CRANE MERCHANDISING SYSTEMS SERVICE INFORMATION M134.0

MODELS AFFECTED: All BevMax 4/3 Model Venders.

Released: 8/26/14 RE: Crane Merchandising Systems DN5800/3800-4 & DN5800/3800-3 Delivery Cup Deflector.

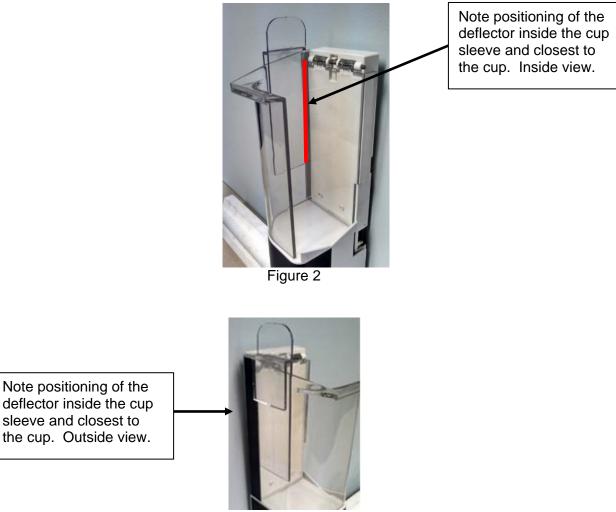
Reason: To provide installation instructions when installing the Delivery Cup Deflector. This is used for packages tipping and not making it in the Delivery (Picker) Cup. This problem is seen with the new taller bottles with a higher center of gravity and wider diameter at the shoulders. If you have any issues please contact your Crane Merchandising Systems Representative or the Technical Service Department at 803-266-5001.

1. Deliver Cup Sleeve Deflector should be installed with the longer end inside the cup sleeve and should be justified to the corner closest to the cup body. (see Figure 2).
